Subject: Oconee Nuclear Station  
Docket Numbers 50-269, -270, -287  
UFSAR Chapter 15 Transient Analysis Methodology,  
Topical Report DPC-NE-3005-P, Revision 1

Responses to Request For Additional Information  
DPC-NE-3005P Revision 1

Figure 1

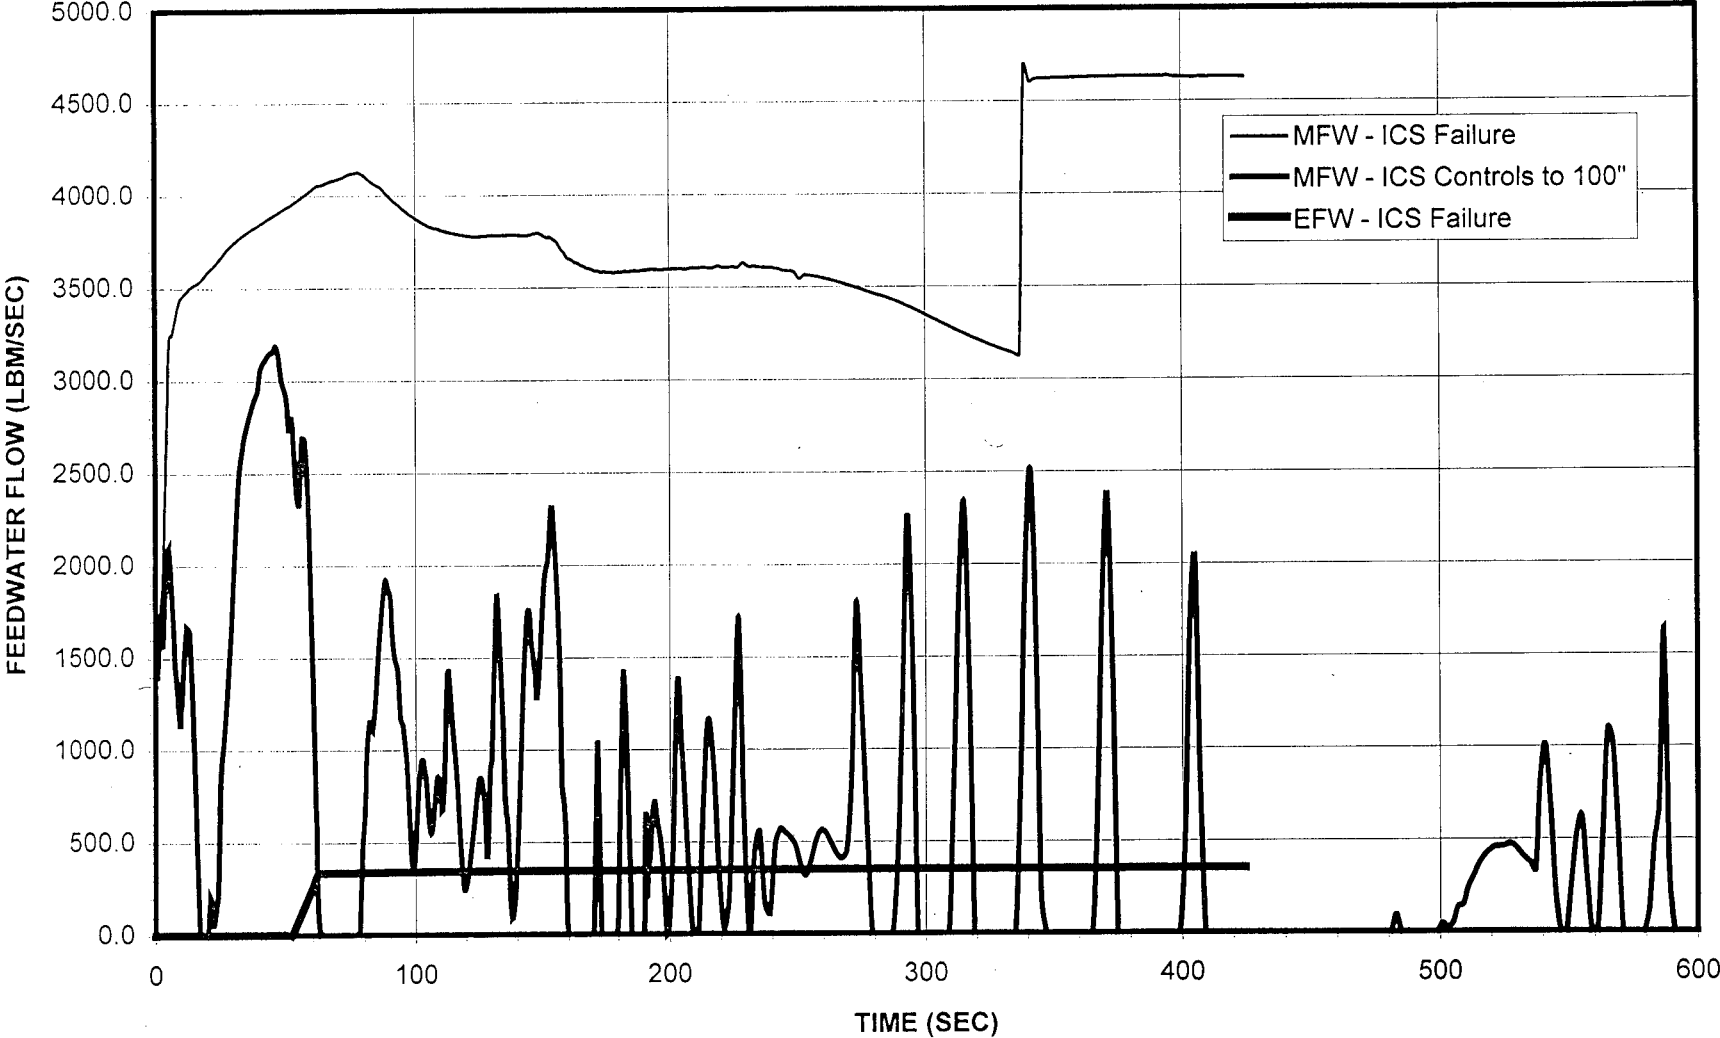
- Q6. Page 15-14 states that the limiting assumption with respect to maximizing overcooling and reactivity addition has been determined by analysis to be the case when the Integrated Control System (ICS) is controlling main feedwater. This case was found to cause more overcooling than the case that assumes failure of the ICS, which would permit unlimited main feedwater addition to the affected steam generator. Provide comparisons of the conditions within the affected steam generator secondary that would cause the ICS operating case to be the worst case. Compare steam generator level, pressure, temperature, and heat transfer coefficients that are calculated by the RETRAN code.

Figure 1 shows the feedwater flowrates to the affected steam generator. With the ICS controlling level to 100 inches, the MFW flow is throttled, whereas for the ICS failed both MFW and EFW flowrates are uncontrolled and much higher. Figure 2 shows the resulting steam generator level. With level control the level is approximately controlled to 100 inches, although the dynamic behavior of the transient causes instability in feedwater control and level response. Without level control the level continues to fill until going offscale at approximately 250 seconds. Figure 3 shows the steam generator liquid mass. With ICS level control the liquid mass is limited to 20,000-50,000 lbm, whereas the overfilled condition without ICS control reaches 180,000 lbm. The significant difference in the feedwater flow boundary condition for the two cases is evident.
